From: [REDACTED]
To: [REDACTED]
Sent: 4/5/2021 8:38:19 AM
Subject: FW: O8W-PM 35217268, 35224712, 35224713 - Bucks Creek 1101 Phase 1,2&3 - Pre-Engineering Meeting

Subject: O8W-PM 35217268, 35224712, 35224713 - Bucks Creek 1101 Phase 1,2&3 - Pre-Engineering Meeting

PM 35217268 (Phase 1)

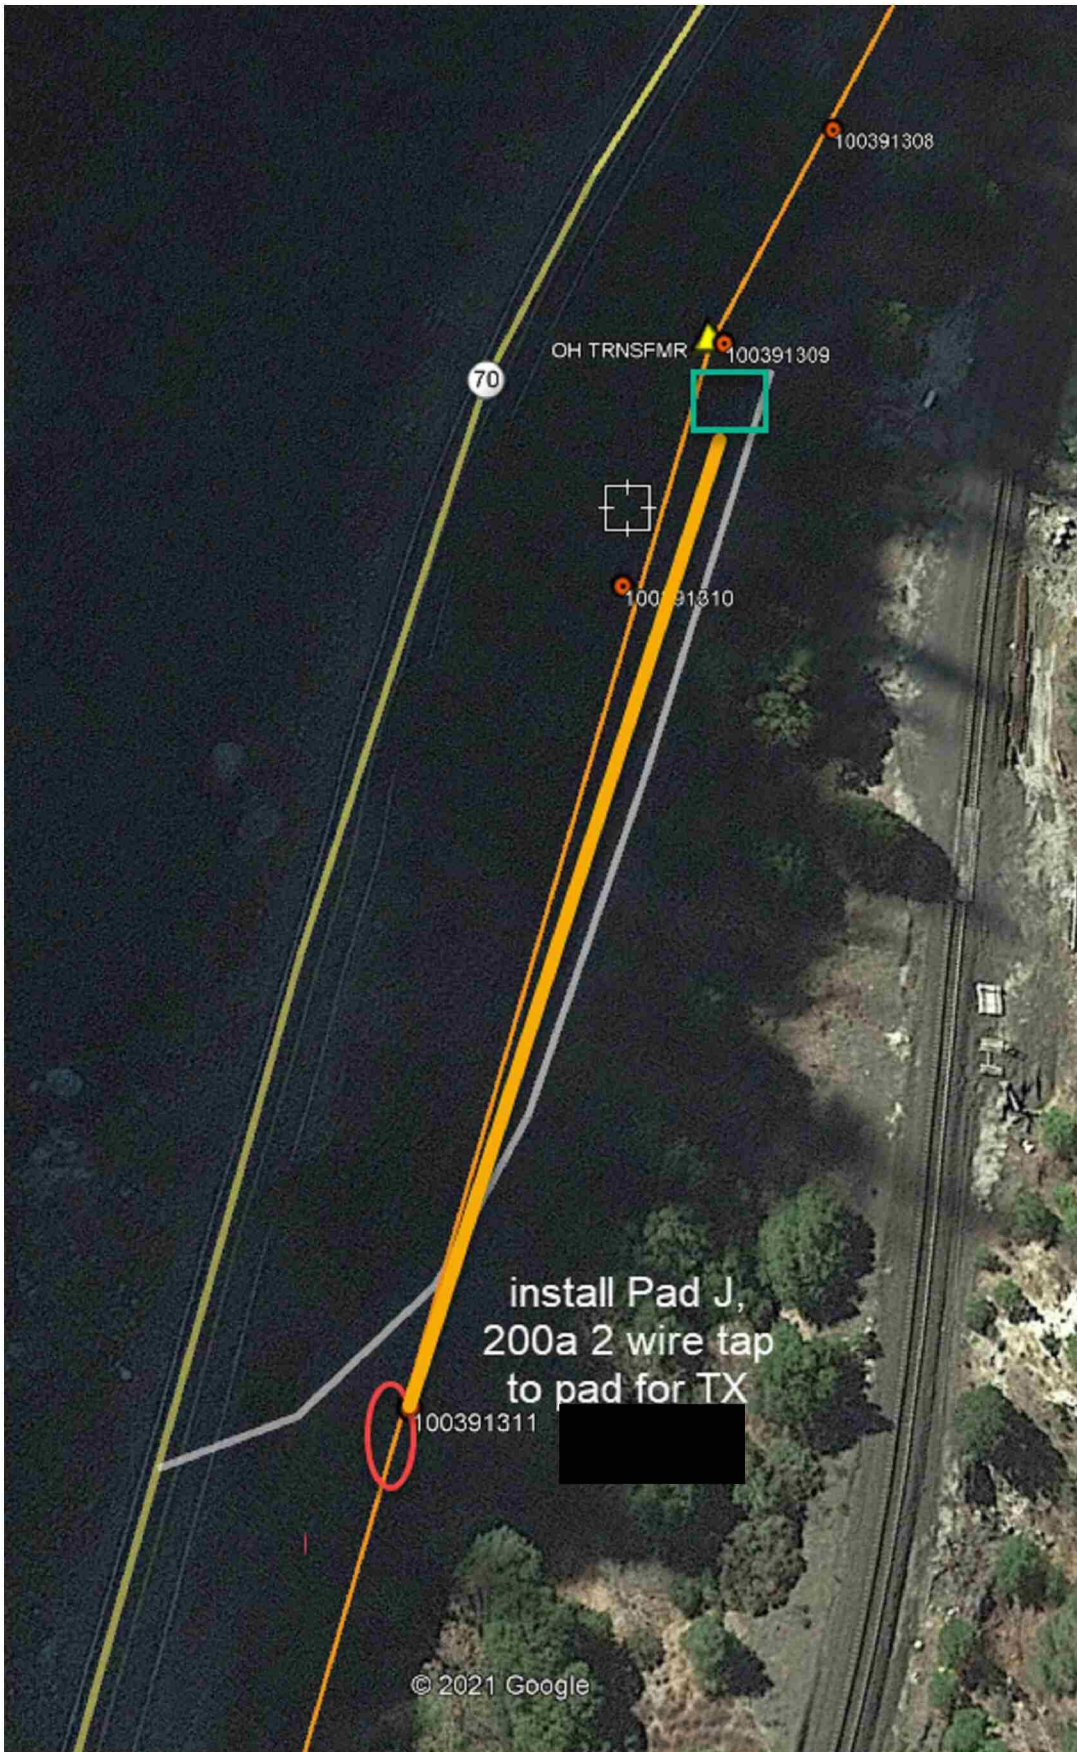
Your outlet red-line Bucks Creek looks close to what I was thinking. Need to work with [REDACTED] to get this designed with a single 6" and use #5 boxes with 200A cable. There is not a reason this will need (2) 6" and 1-4" and 7 boxes. There is probably only 20a peak on the primary now.

Also need to see what Hydro is willing to do with the TX for the penstock metering valve at Rock Creek PH. It will be a long way up from the

Need to see if Hydro has GPR data for the Hwy 70 road bed to see if we can get 42" minimum cover and keep clearance over any hydro facilities.

Merlin can go back like we just did. Pad on the Highway and tension secondary 1/0 ASCR across the river. We can negotiate to move service point with my MSA electrician.

Should be able to take a pad here and get the dam a UG service. For Cal trans riser up and go in the back of the first tunnel window, leave the old TX pole, top it and use to splice in UG service feed.
